State of Alaska  
Department of Fish and Game  
Sportfish Division

Nomination Form  
Anadromous Waters Catalog

Name of Water Body Ninemile Creek  USGS Name  Local Name

## **CORRECTION**

Figure 1.-111-50-10670 route correction map.

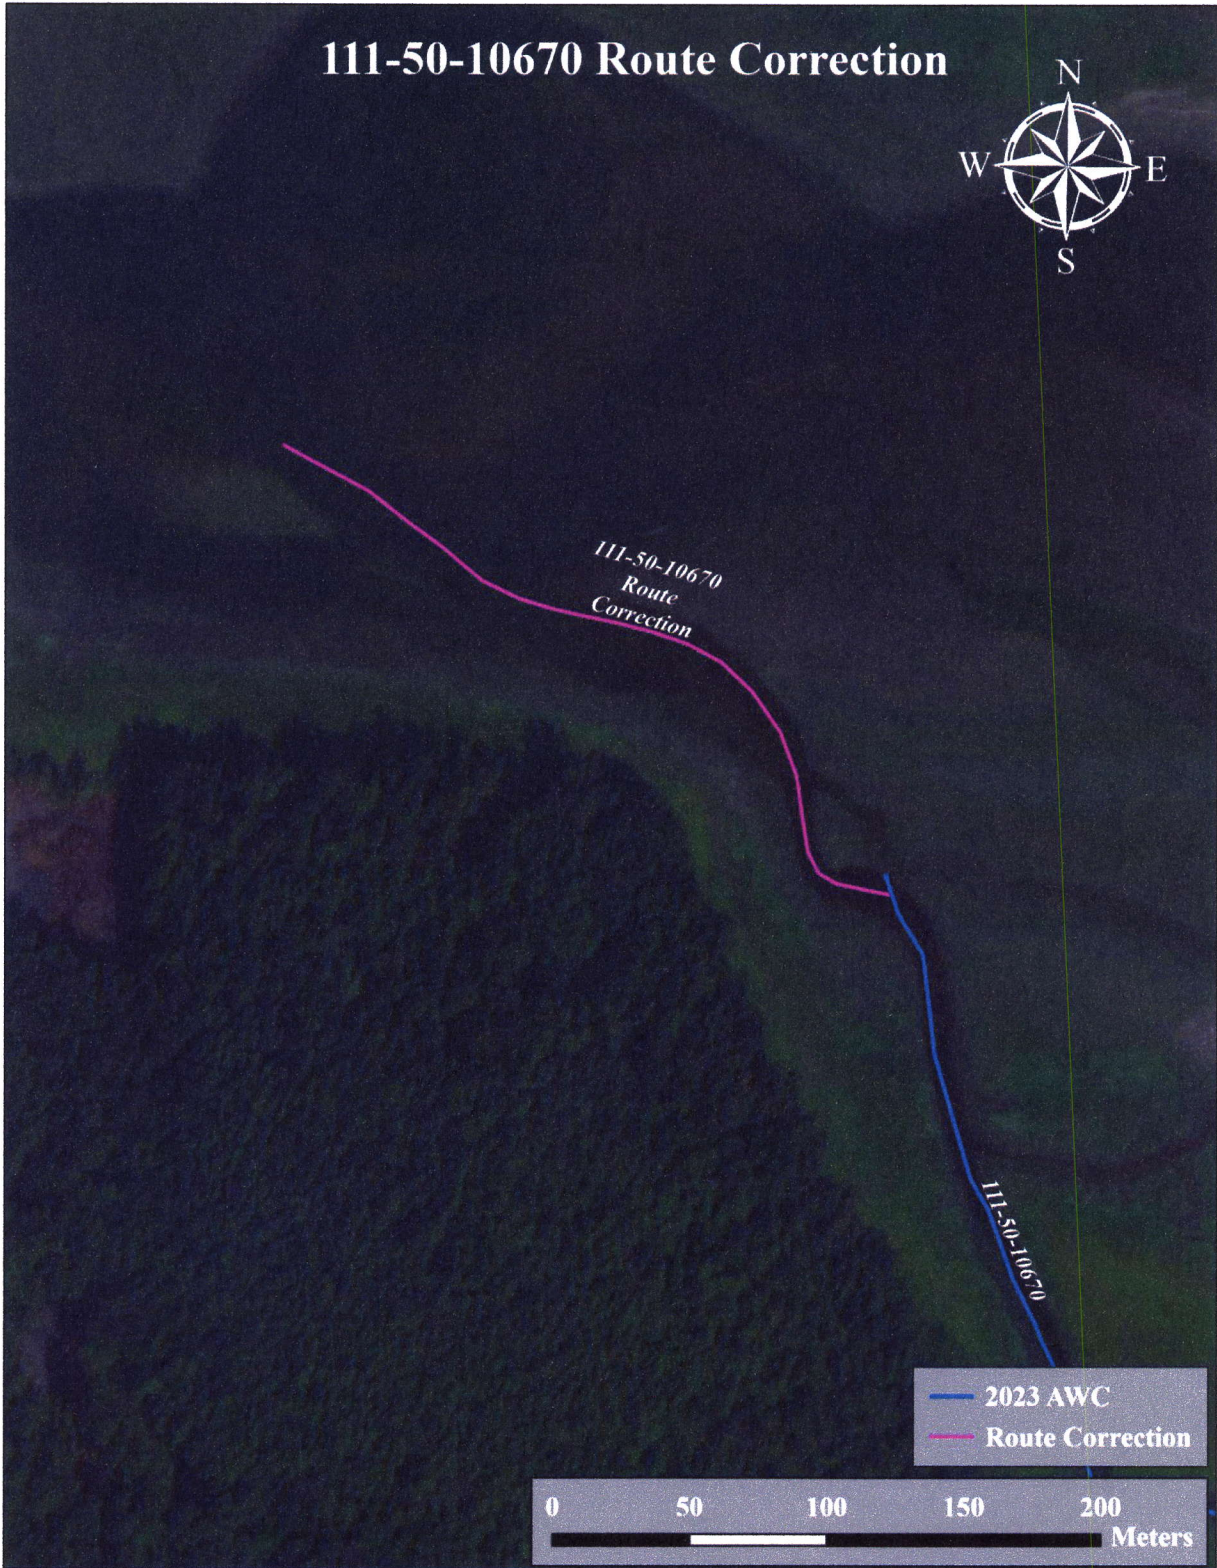
**Findings:** We surveyed this cataloged stream and found that the stream path is incorrectly mapped. The lower reach of the stream should be extended for clarification, particularly in light of potential alternatives identified for eventual construction of a second bridge crossing between Juneau and Douglas.

**Recommendations:** Correct Stream No. 111-50-10670 in the anadromous waters catalog to reflect the field verified stream path. Please extend stream into the intertidal (Figure 1).

~UPDATE/RELOCATE mouth point position of existing AWC Stream #111-40-10908 to better approximate the location of Mean-Low-Low-Water (MLLW).

GHS, COp, Pp, DVp  
new LOWER

DELETE  
delete old lower
